## **RIVER FOREST SUBDIVISION,** **RESUBDIVISION OF LOT 35**

APPLICATION NUMBER 2 DATE March 15, 2007

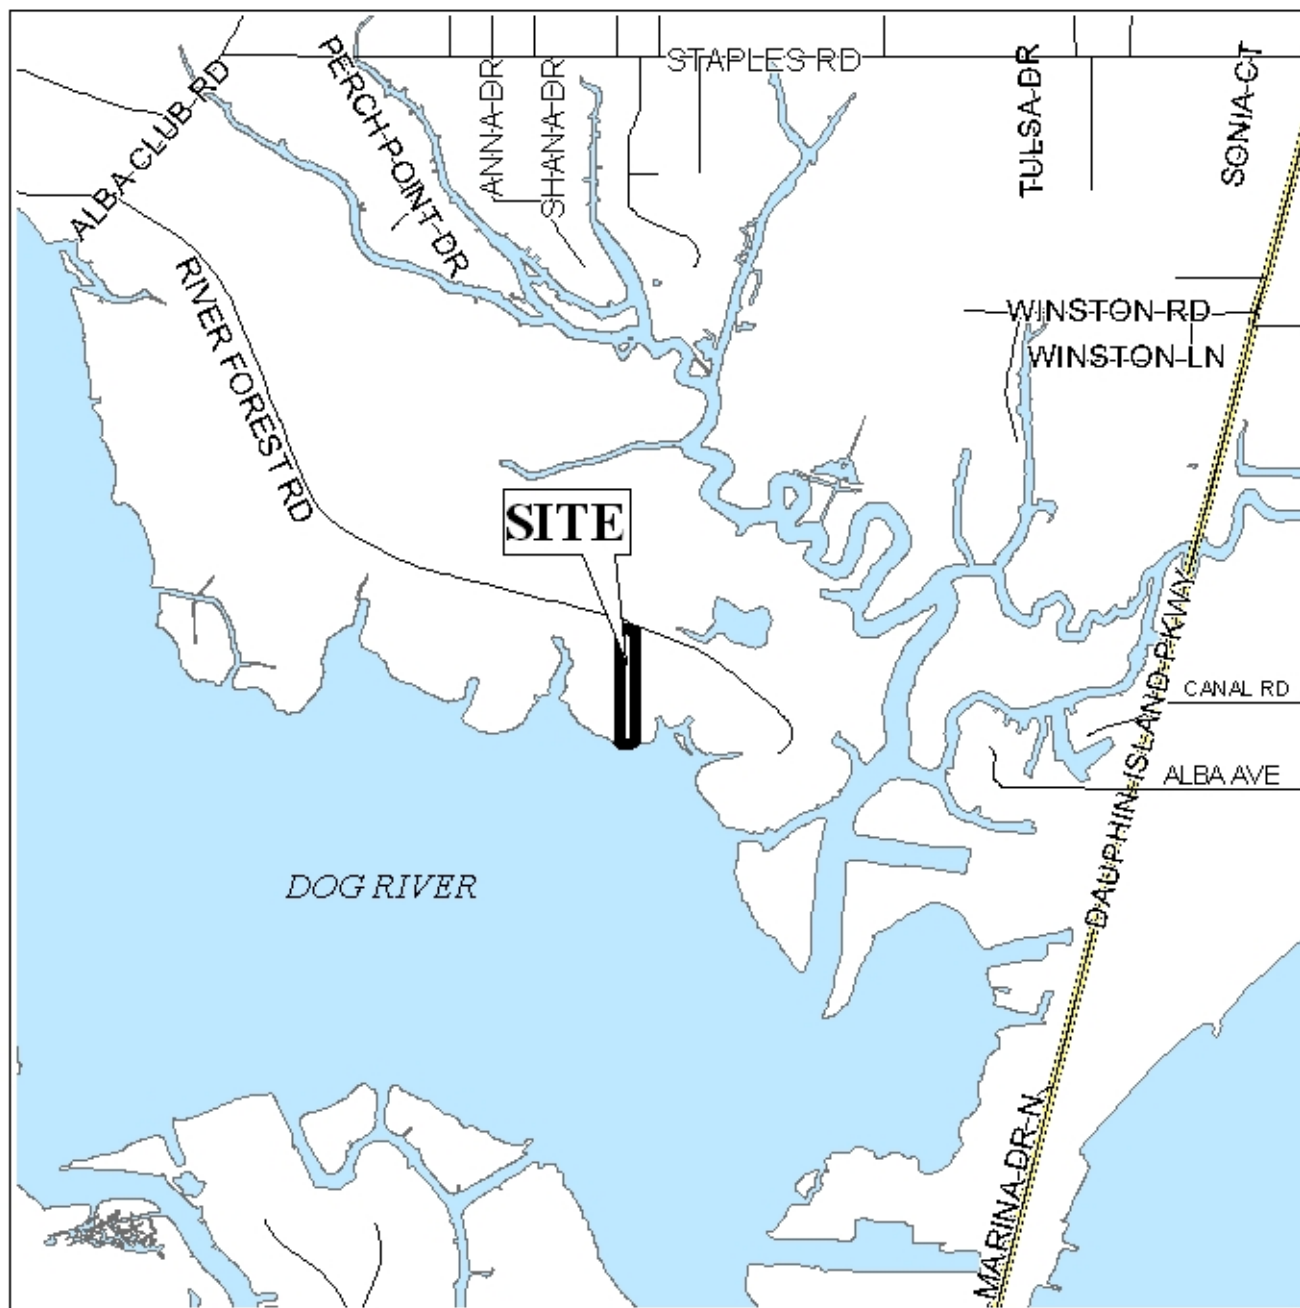
Engineering Comments: Show minimum finished floor elevation for any buildings or structures and/or slabs, on which, mechanical and electrical equipment will be installed. The storm water ordinance does not allow water to be concentrated onto an adjacent property without a hold harmless agreement. Must comply with all storm water and flood control ordinances. Any work performed in the right of way will require a right of way permit.

Traffic Engineering Comments: Driveway number, size, location, and design to be approved by Traffic Engineering and conform to AASHTO standards.

The proposed lots will exceed the depth to width ratio recommended by Section V.D.3. of the Subdivision Regulations. It should also be pointed out that lots exceeding the recommended depth to width ratio are common along Dog River, thus a waiver of Section V.D.3. may be appropriate.

The site fronts onto River Forest Road, a minor street with adequate right-of-way. While River Forest Road is a minor street, access management is a concern. Each lot should be limited to one curb-cut onto River Forest Road, with the size, design and location to be approved by Traffic Engineering and conform to AASHTO standards.

The site is bounded to the South by Dog River, and wetlands and floodplains associated with the waterway may occur on a portion of the site. The presence of wetlands and floodplains indicate that the area may be environmentally sensitive; therefore, the approval of all applicable federal, state and local agencies would be required prior to the issuance of any permits or land disturbance activities.

With a waiver of Section V.D.3., the plat is recommended for Tentative Approval, subject to the following conditions: 1) placement of a note on the plat stating that each lot is limited to one curb-cut each onto River Forest Road, with the size, design and location to be approved by Traffic Engineering, and comply with AASHTO standards; 2) labeling of each lot with its size in square feet, or provision of a table on the plat with the same information; 3) placement of a note on the plat stating that approval of all applicable federal, state and local agencies is required prior to the issuance of any permits or land disturbance activities; 4) compliance with

Engineering comments (*Show minimum finished floor elevation for any buildings or structures and/or slabs, on which, mechanical and electrical equipment will be installed. The storm water ordinance does not allow water to be concentrated onto an adjacent property without a hold harmless agreement. Must comply with all storm water and flood control ordinances. Any work performed in the right of way will require a right of way permit.*); and 5) full compliance with all other municipal codes and ordinances.
